## **MEMORANDUM**

**DATE:** October 10, 2025

**SUBJECT:** BZA Case 21352: Request for special exception relief to remove a rooftop architectural element of an existing semidetached, two-story w/ cellar, principal dwelling unit in the RF-1 Zone.

Figure 1. Illustration of supportable turret alteration

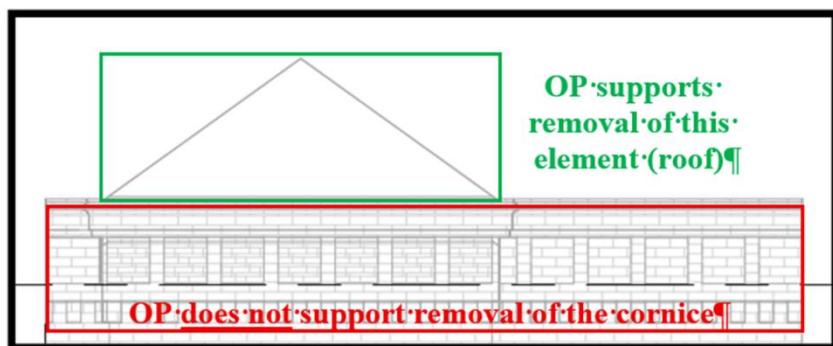
OP has advised the Applicant that this recommendation of approval is predicated on the understanding that only the removal of the pitched roof portion of the existing turret is supported, and not the entire turret or the cornice at the top of the turret) as illustrated below. The Applicant has agreed to this modification, to retain the entire cornice.

OP does not recommend special treatment in this case, other than the retention of the full cornice element at the top of this building and the turret as proposed.
